RE: Nottingham Woods Preliminary Site Plan
City File #15-004, Parcel 15-22-376-039

From: Sara Roediger, AICP
Date: 7/24/2015
Re: **Nottingham Woods (City File #15-004)**
Preliminary Site Condominium Plan - Planning Review #2

From: Jason Boughton, ACC *JRB*
To: Sara Roediger, Manager of Planning
Date: July 24, 2015
Re: Nottingham Woods, City File #15-004, Section #22
Site Plan Review #2

CITY OF ROCHESTER HILLS
STANDARD DETAIL FOR:
Sight Distance
Pathways

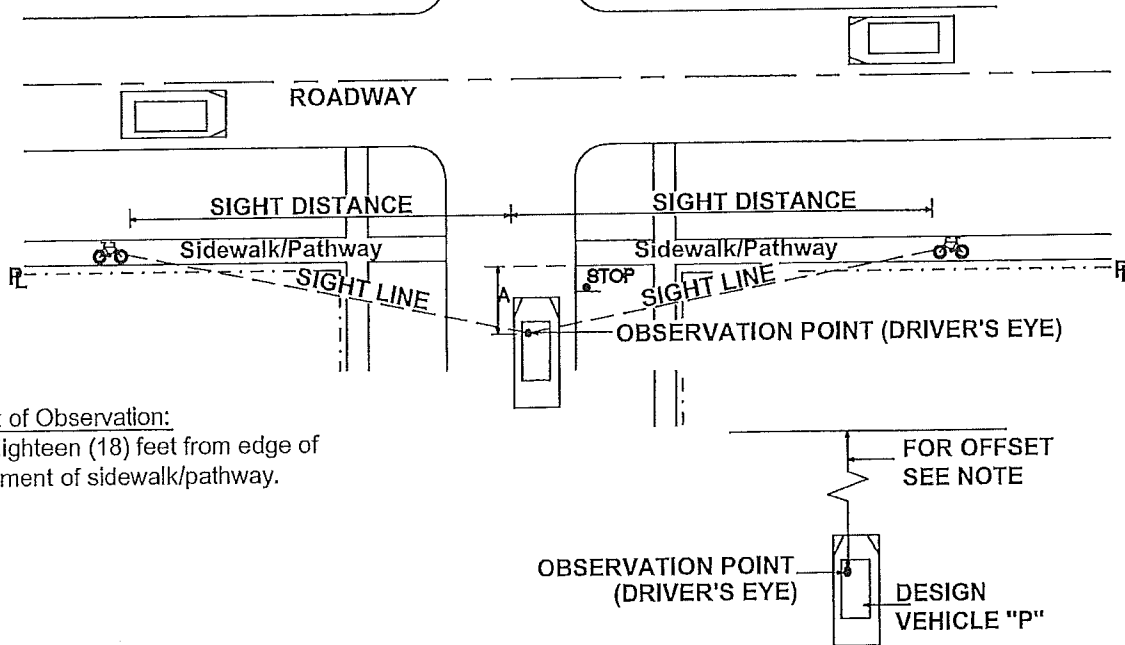
4. *The first Shagbark Hickory tree west of the approach is within the pathway clearance area. See attached detail.*

1. The 3 Shagbark Hickory trees appear to be proposed at less than the 5 feet required from edge of pathway.
2. The first Shagbark Hickory tree west of the approach is within the pathway clearance area. See attached detail.

The proposed tree location will be adjusted, as requested, and the clearance area will be shown on the plans.
